E/ECE/324
E/ECE/TRANS/505 | Rev.1/Add.74/Rev.1/Amend.2

Addendum 74: Regulation No. 75

Revision 1 - Amendment 2

UNIFORM PROVISIONS CONCERNING THE APPROVAL OF PNEUMATIC TYRES FOR MOTOR CYCLES AND MOPEDS

"Enveloping curve for centrifugal growth test

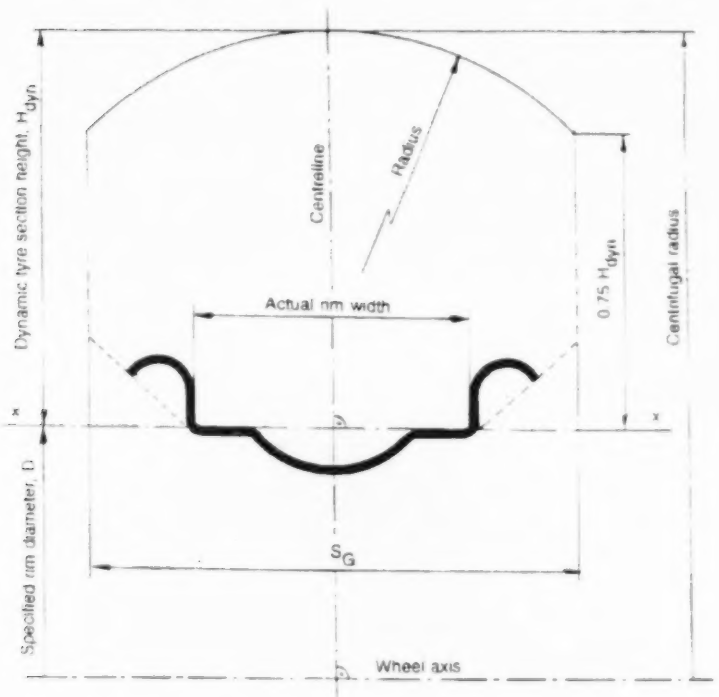
Annex 9, paragraph 4.1., replace the example drawing by the following:

S_G = Maximum overall width in service
(This changes 1 mm per 0.5 mm width code change from the measuring rim)

H_{dyn} = Centrifugal radius - D/2."
